Final Drainage Report

Kum & Go Store #2232

**Pedrick-Eckerd Filing No. 3
Lot 2
El Paso County, Colorado**

PCD File No. PPR-2225

Profile Report
Engineering Profile - P3 (1 - StormCAD Model.stsw)

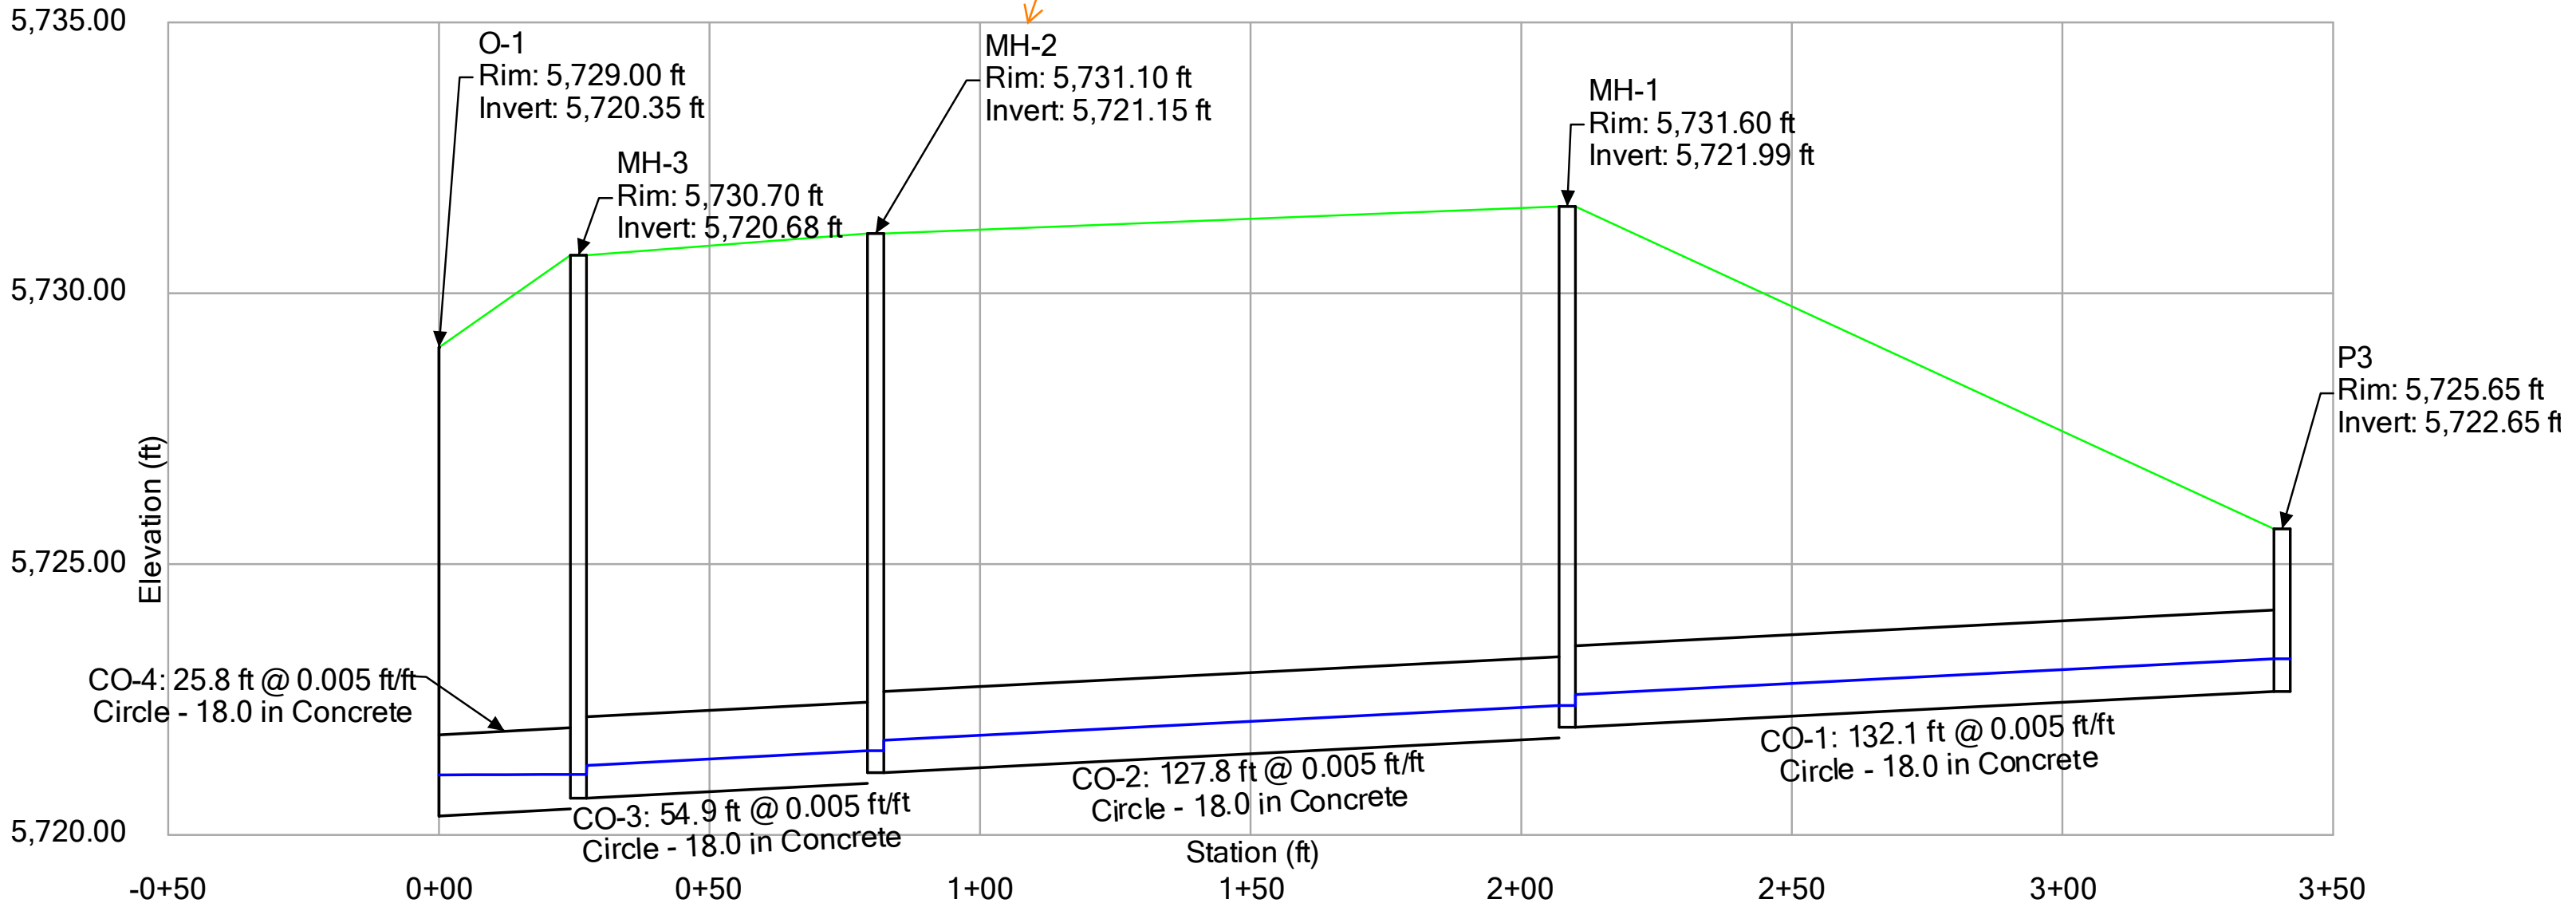
Are these MH labels (MH-1, MH-2, etc) on plan drawings somewhere? I'm not seeing them on the drainage maps below. Please show labels on plans.

These names are specific to the StormCAD model. The StormCAD model has been updated to include a title for clarity

2232 - EL PASO, COLORADO
 SECURITY BLVD. AND MAIN ST.
PROPOSED DRAINAGE PLAN

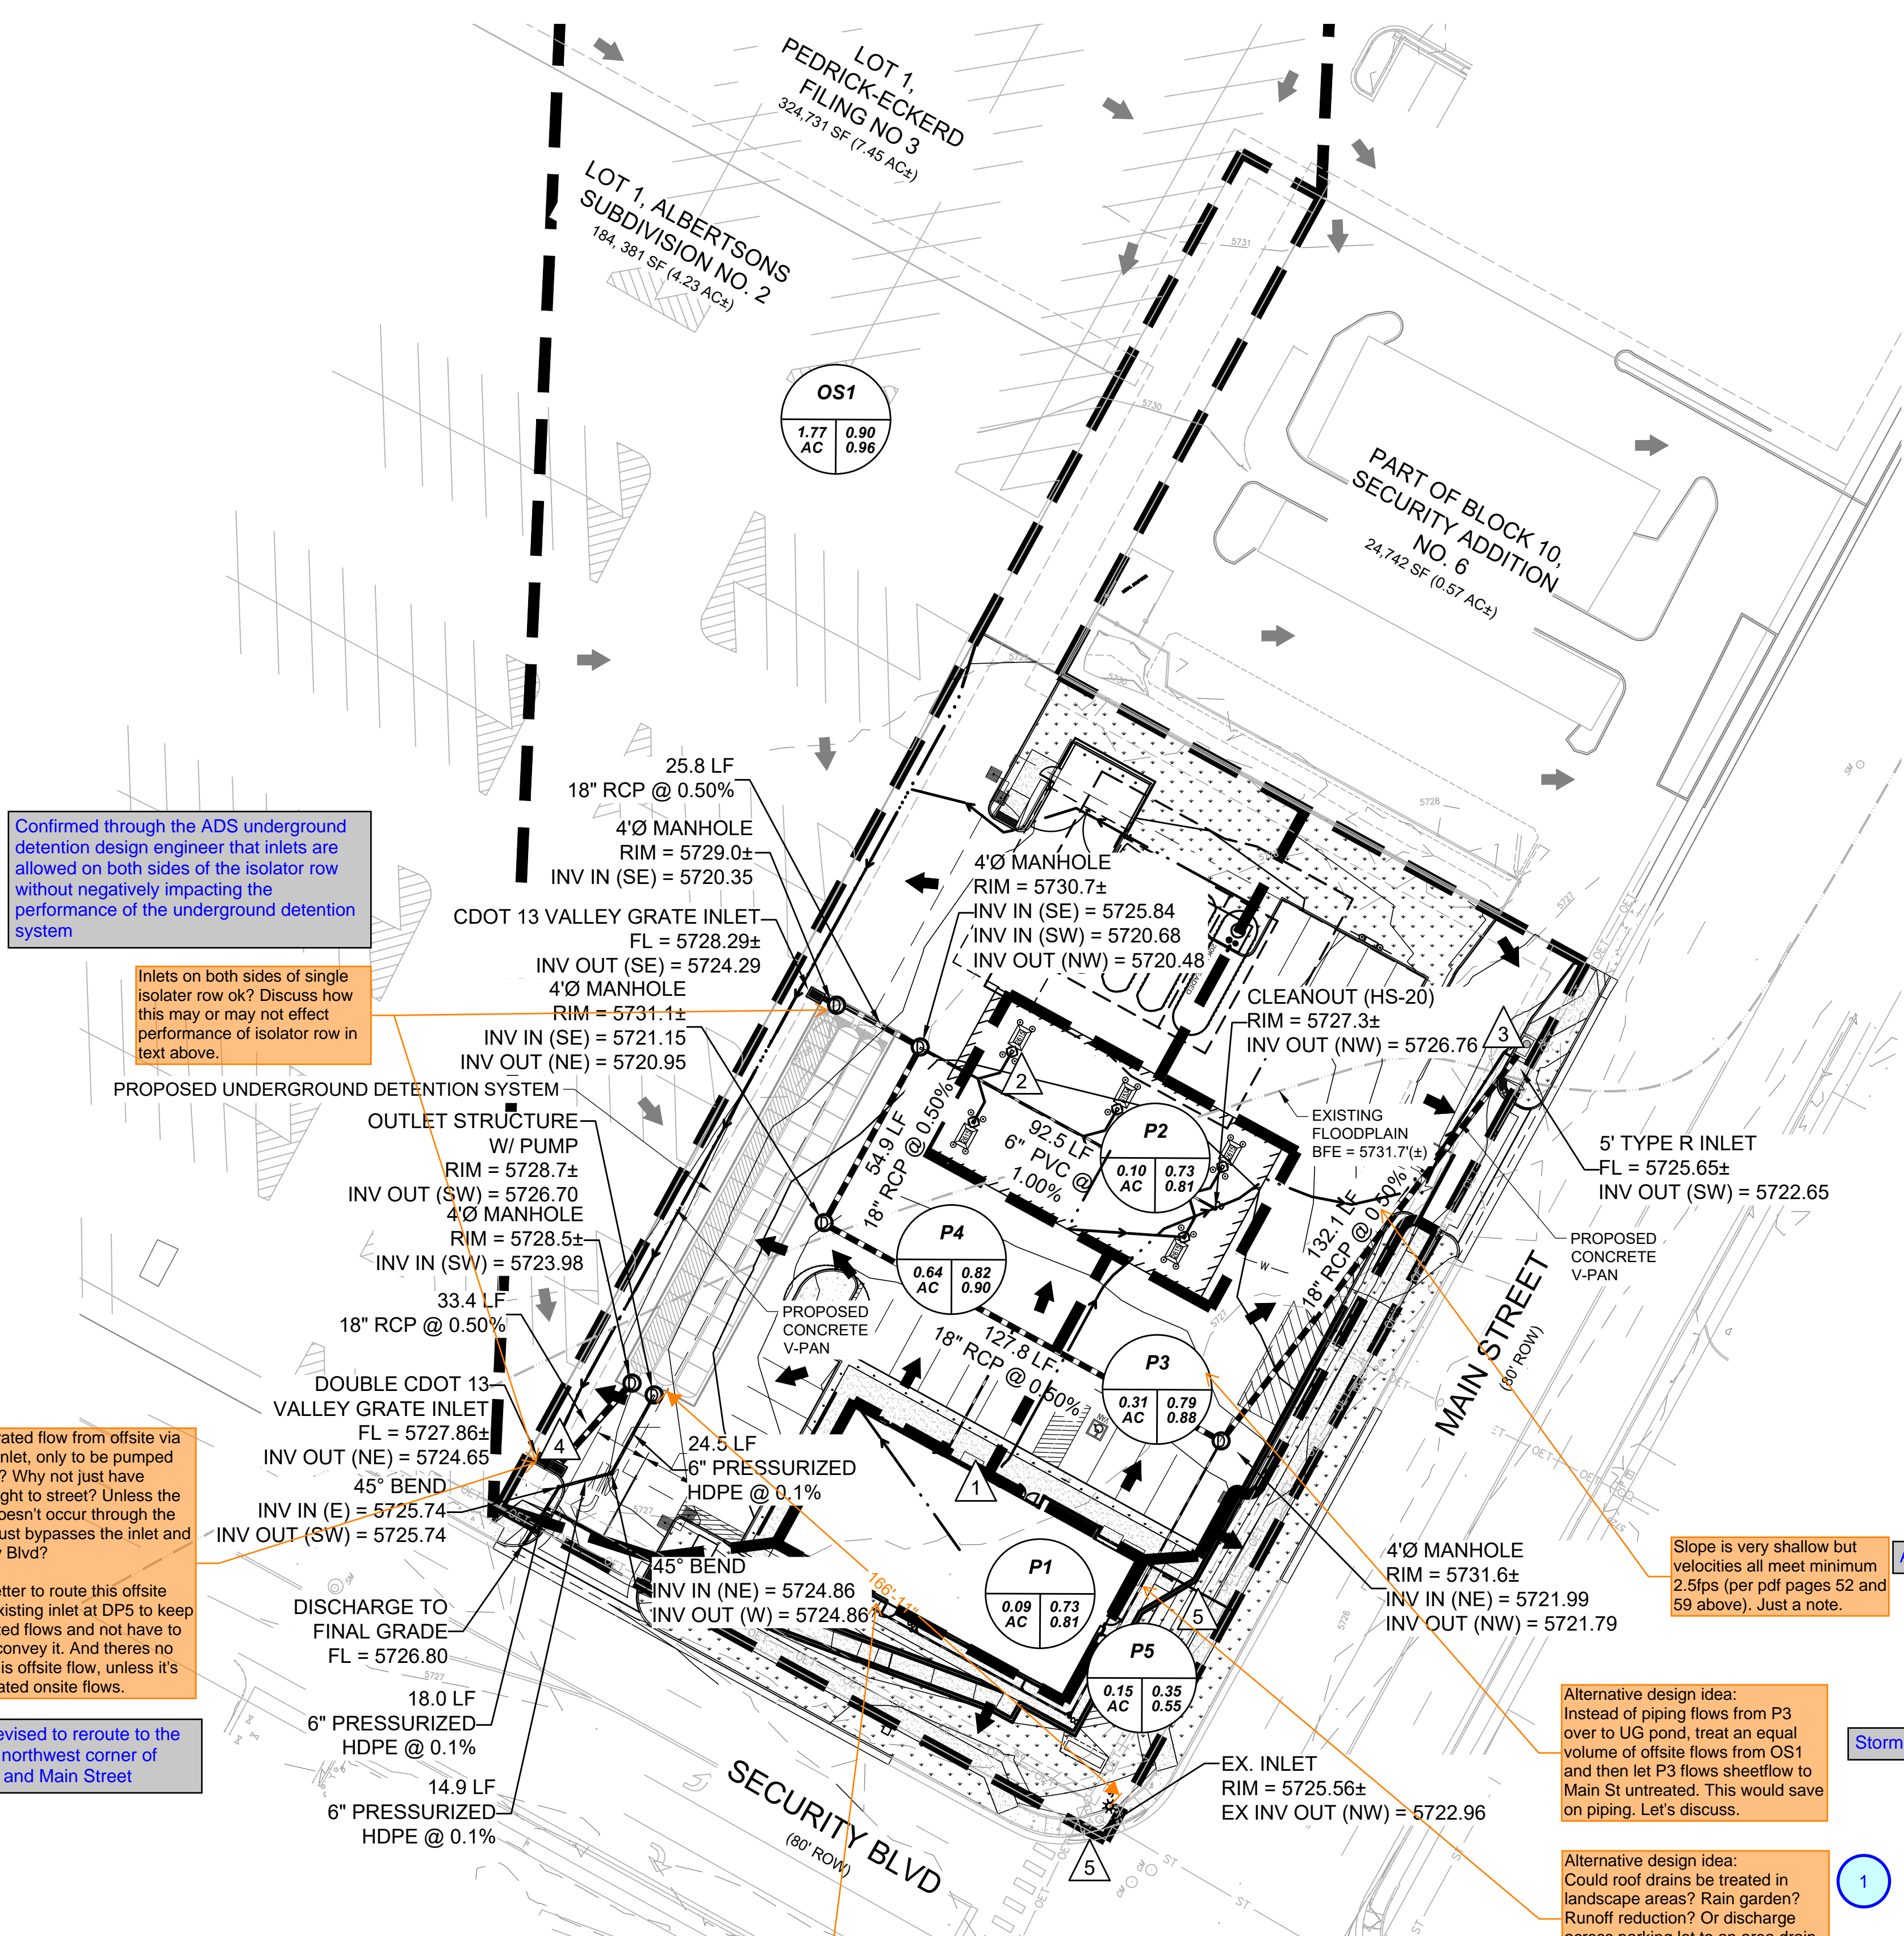
Show existing flow arrows in Main St and Security Blvd.

Alternative design idea: Instead of piping flows from P3 over to UG pond, treat an equal volume of offsite flows from OS1 and then let P3 flows sheetflow to Main St untreated. This would save on piping. Let's discuss.

Alternative design idea: Could roof drains be treated in landscape areas? Rain garden? Runoff reduction? Or discharge across parking lot to an area drain closer to UG pond instead of piped the whole way? Let's discuss.

Flows have been revised to reroute to the existing inlet at the northwest corner of Security Boulevard and Main Street

Existing flow arrows added to Main St and Security Boulevard

Storm design has not been revised

Storm design has not been revised

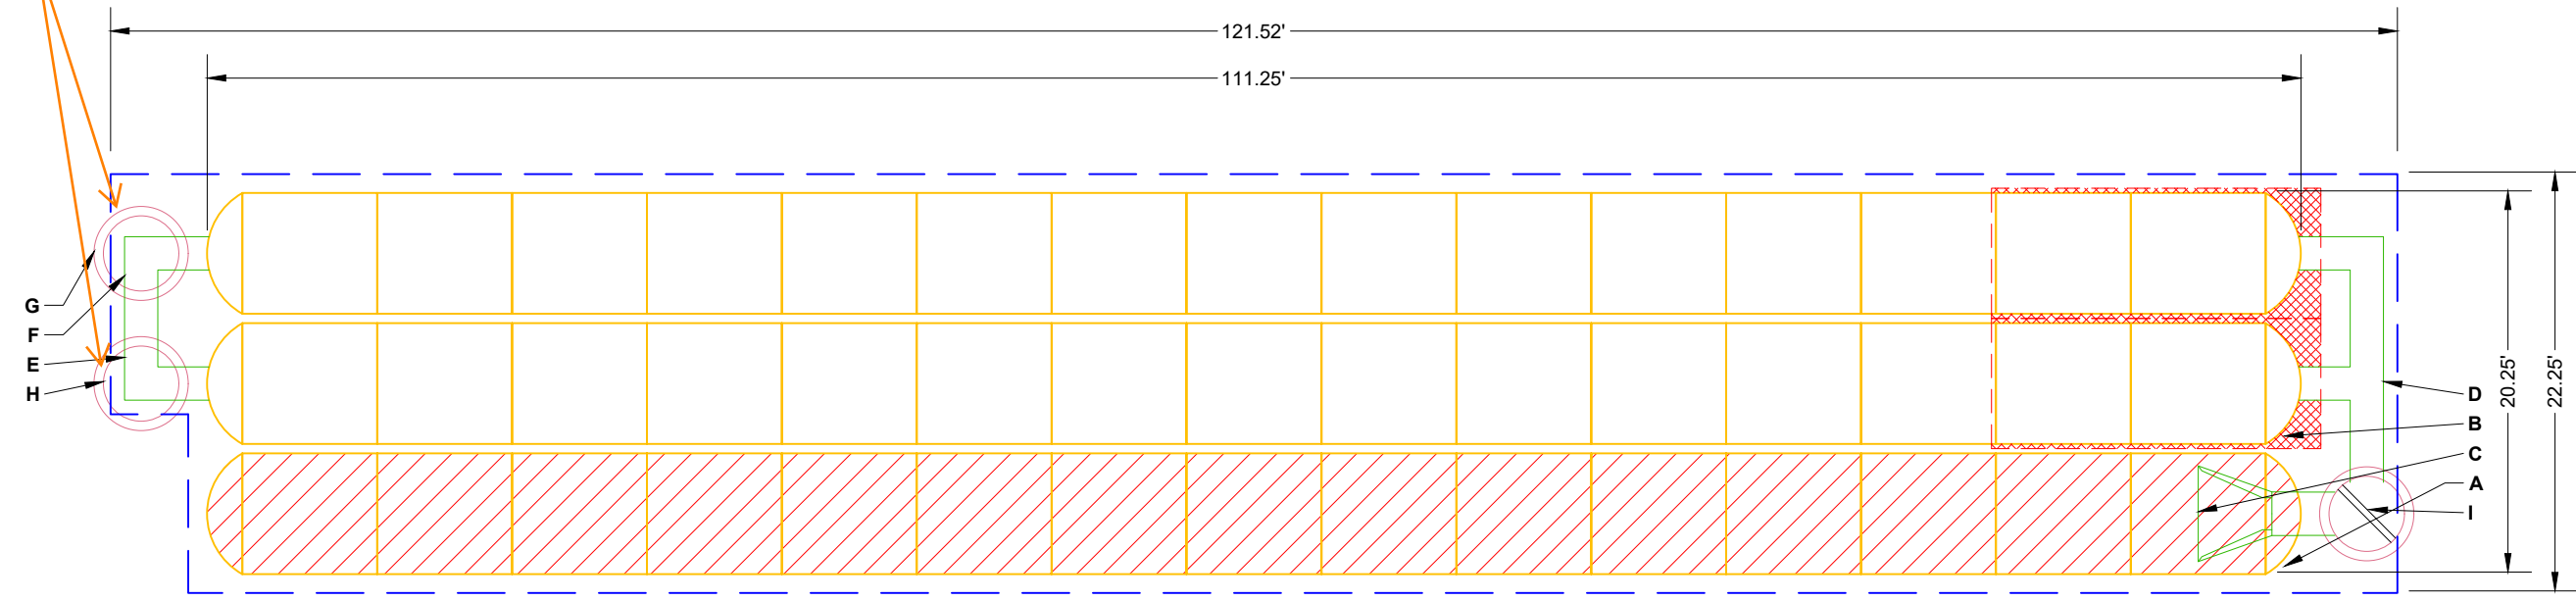
Label which is inlet vs outlet structure.

Provide plans that show the design of these. Plans only provided for outlet structure, not the two inlets.

Show location of inspection port in middle of isolator row.
Add a 2nd inspection port to one of the detention rows above the fabric.

Show north arrow so this sheet is more site specific.

Show hatching going the other direction to match plans.

Manifold is called out in the table at the top of this sheet as 18"x18" so remove this note.
And provide sizing calcs for manifold.

Inlet and outlet structures have been labeled and arrows have been included on the drawing for legibility of inflow and outflow

OCS has been revised to Outlet Control Structure

The proposed drainage plan includes the inlets. The storm plan and profile drawing has also been included in this submittal for clarity.

Inspection port added and inspection ports have been labeled.

North arrow has been added to this plan

Semi-Open Impeller PERFORMANCE DATA 5 - 20 BHP 4" & 6" Flanged Discharge Units 3" Solids Passing Capacity

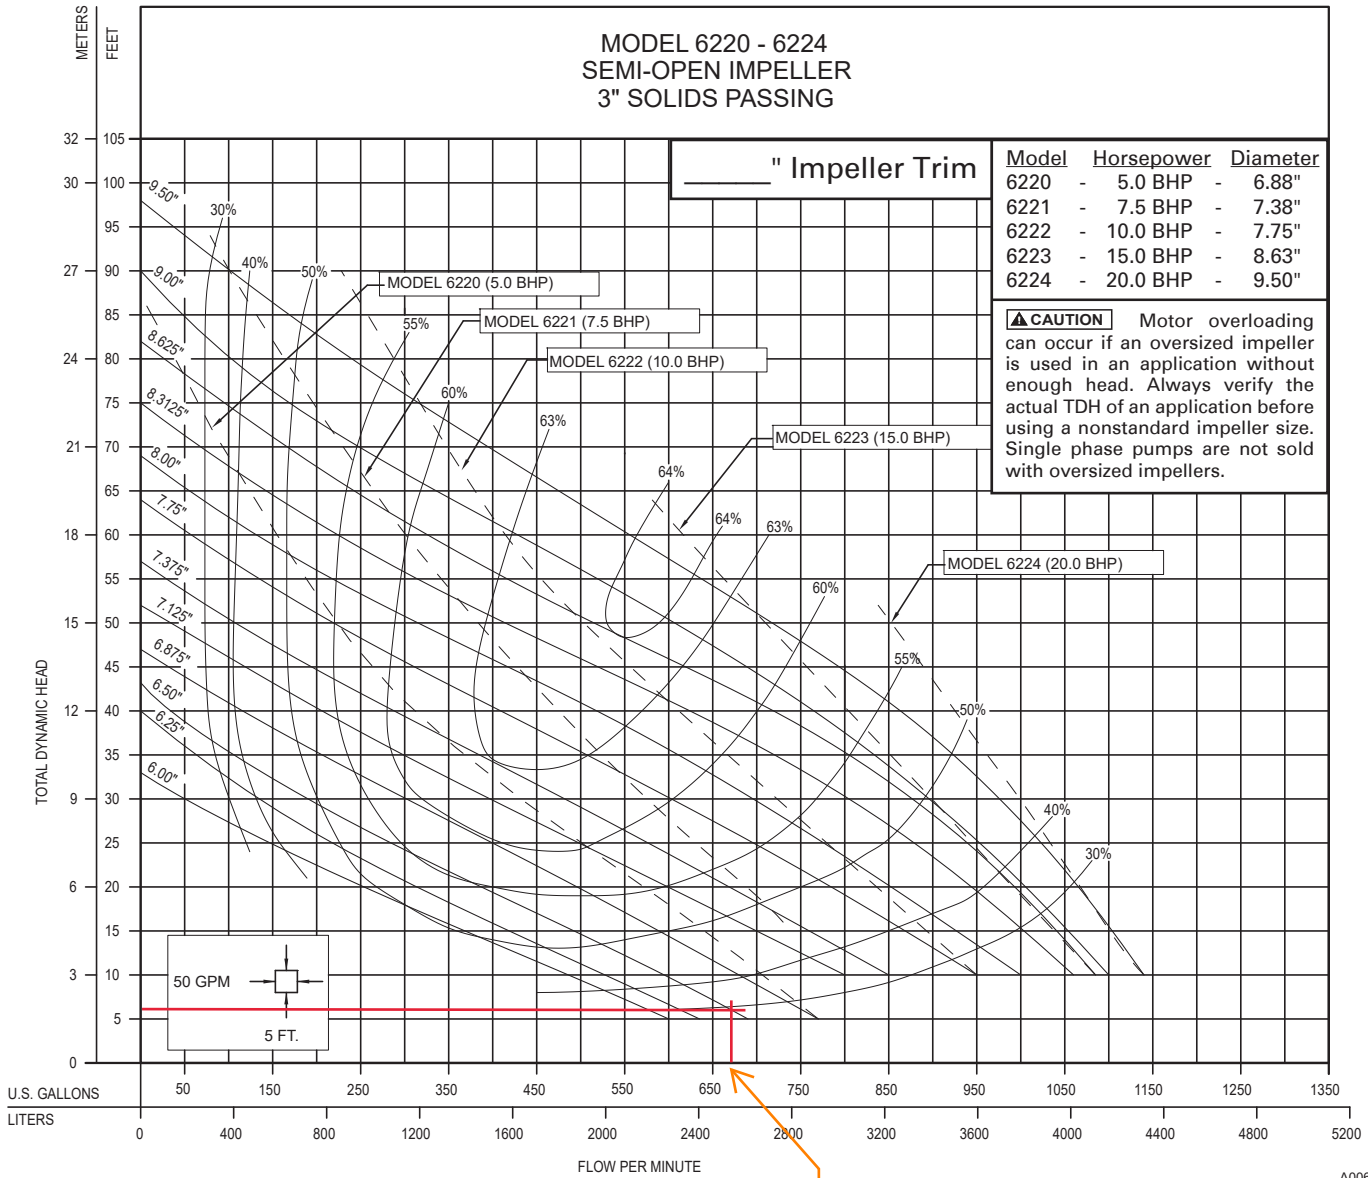
Internal Review Note:
670gpm = 1.5cfs
Peak outflow through orifice
(for 100-yr storm) is 0.29 cfs.
